Tarbert Ferry Terminal Upgrade Construction Licence Variation Request

Date: 27/01/2020

**TEMPORARY BUND
GENERAL LAYOUT**

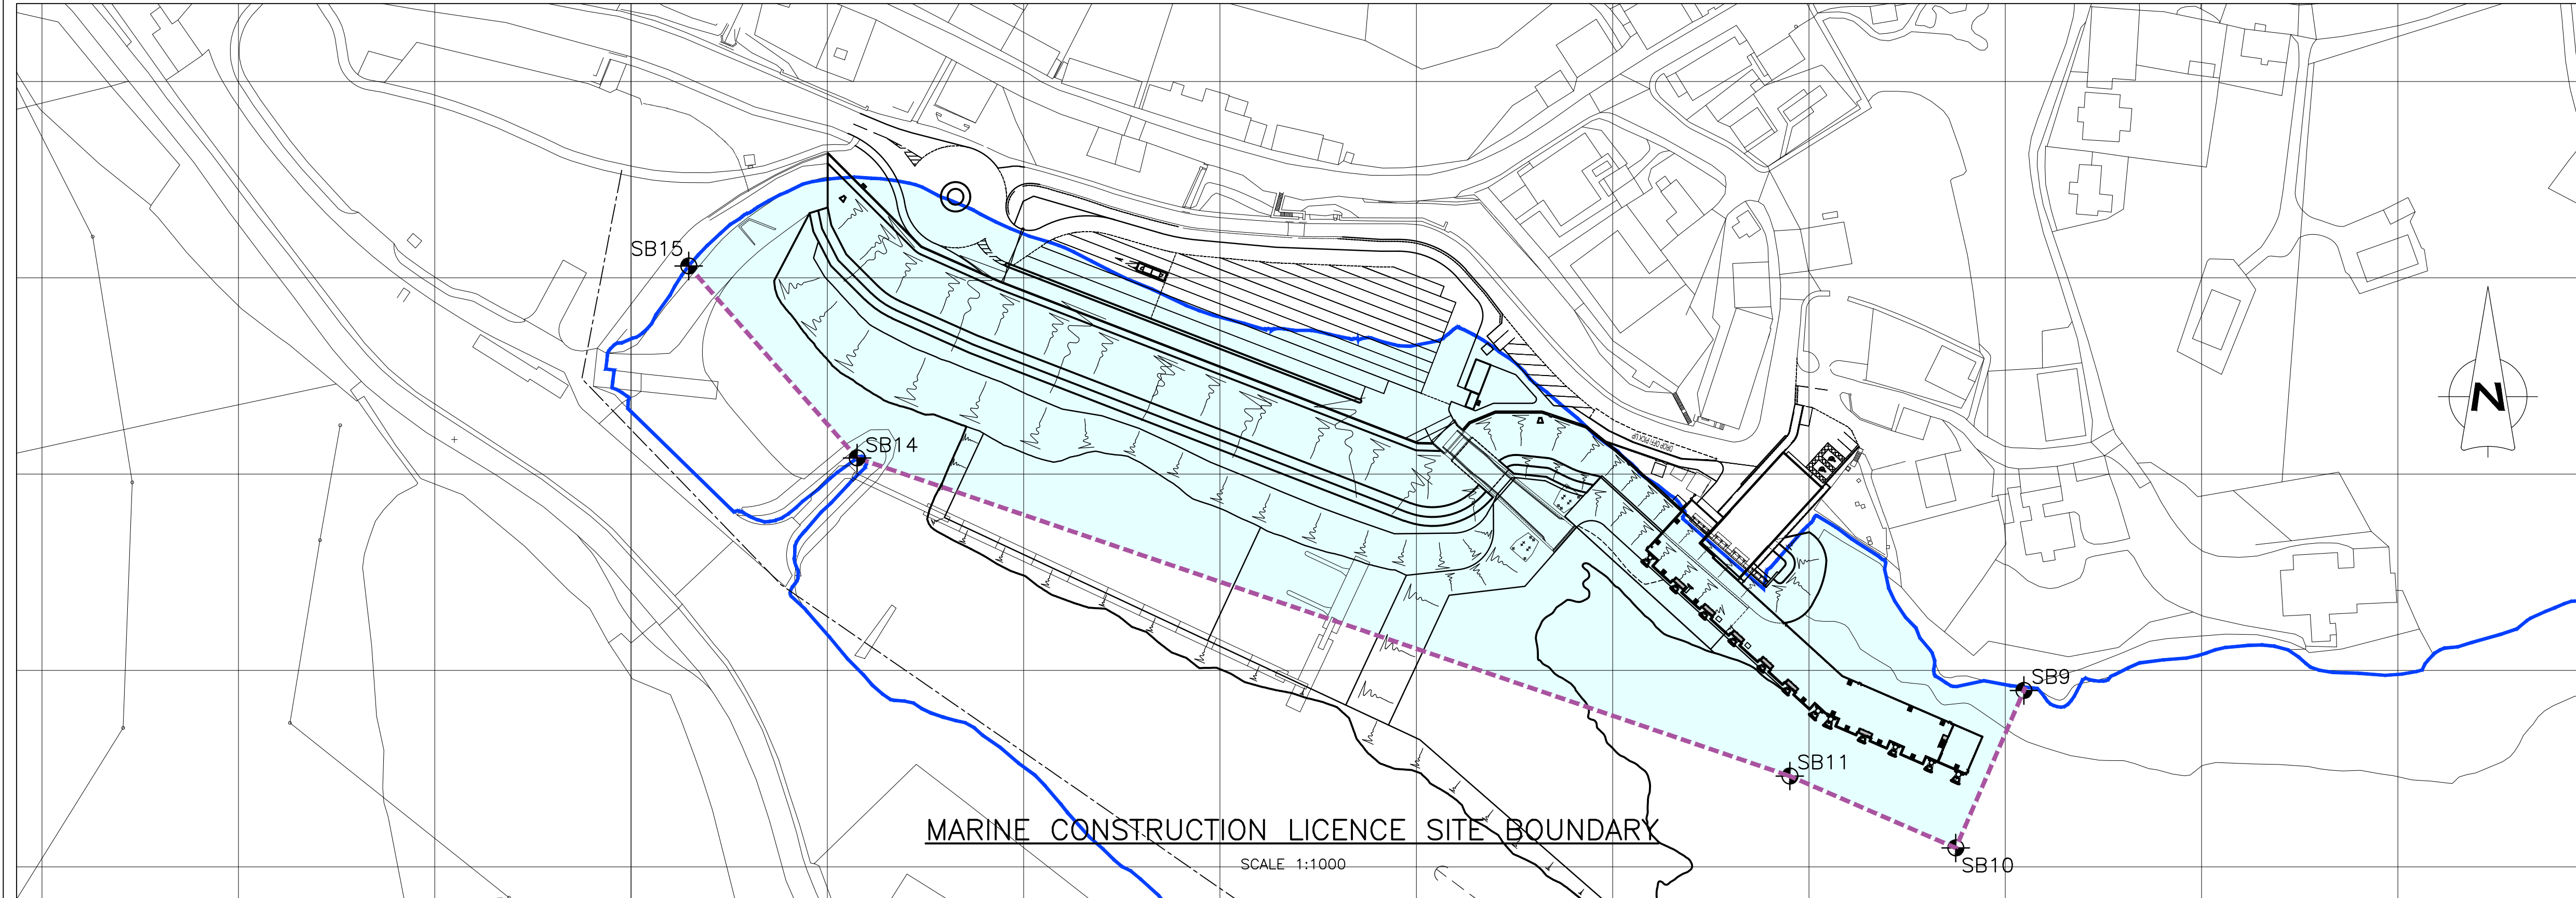
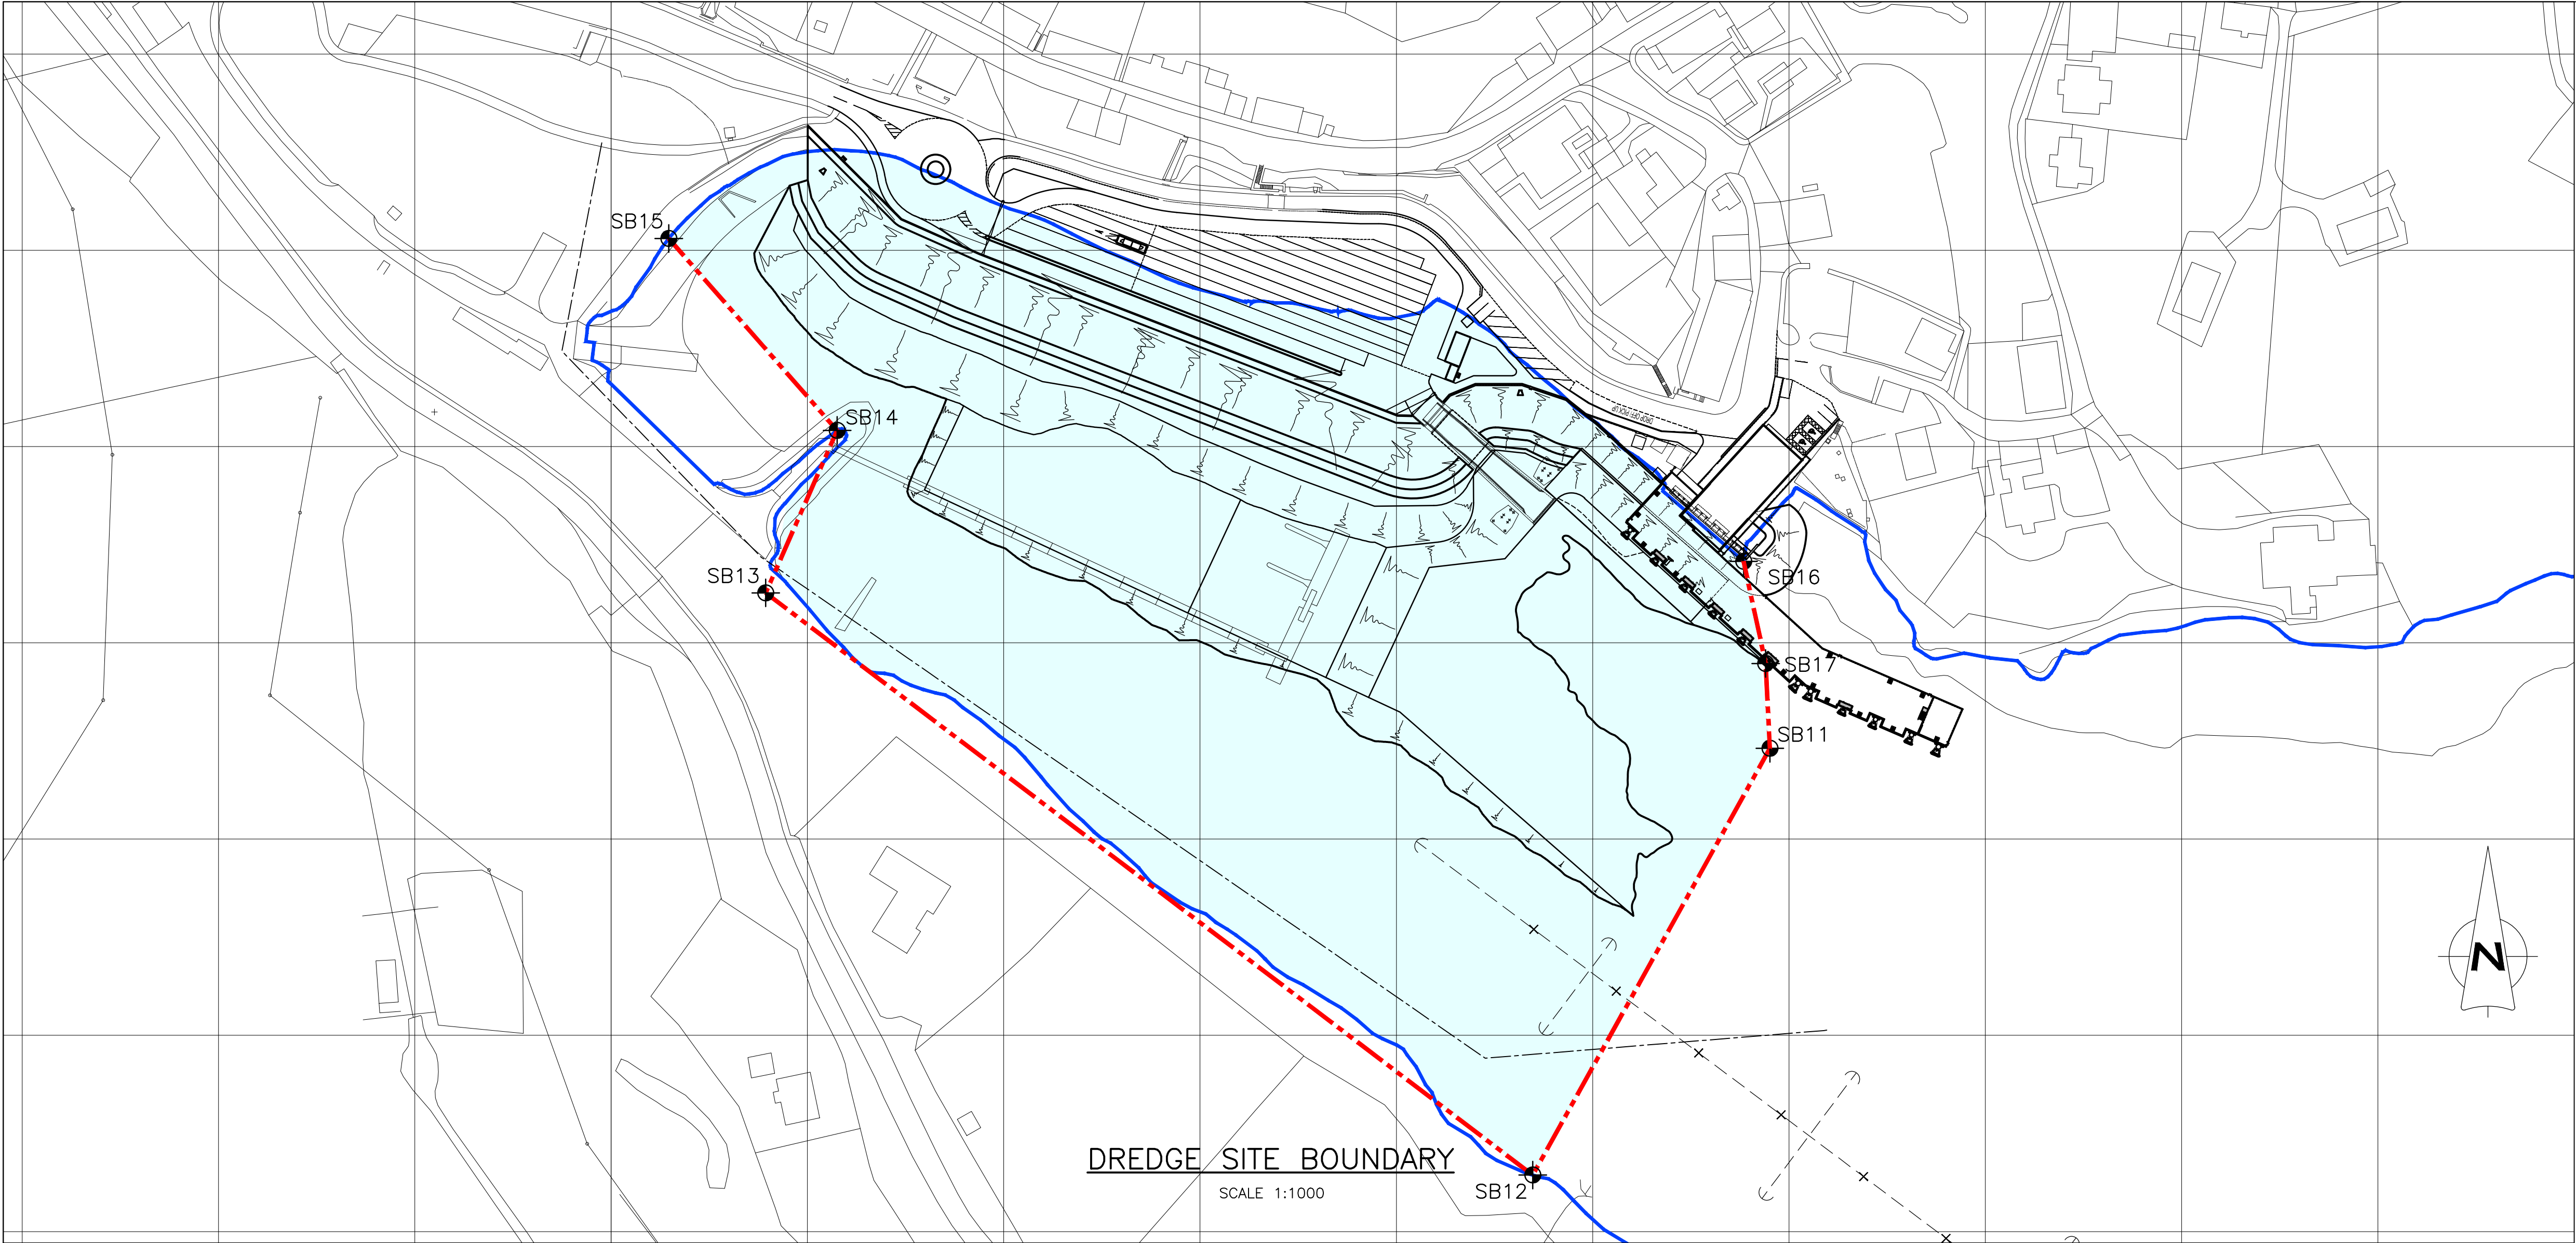
The temporary infill bund will cover an area of 1100m², as shown in Drawing 2210-191B, and will be constructed within the coordinates given in the existing Marine Construction Licence and shown on Drawing 1973-909. Rock will be layered and compacted along the footprint of the infill bund to a final level of +5.5m as shown in Drawing 2210-192B. Primary and secondary rock armour will be placed on the outer edge of the bund, providing a suitable platform to facilitate construction.

The extension and repair work to the foul outfall will be carried out, the proposed extension can be seen in Drawing 2210-191A. The repair works will reduce risk of blockages. In addition, the proposed discharge point is located in slightly deeper waters further into the channel, giving rise to improved mixing and dispersion constituting in a **positive, permanent, medium** magnitude of impact. Given the positive impact, this is likely to give rise to a **positive, long-term** and **moderate: significant** effect.
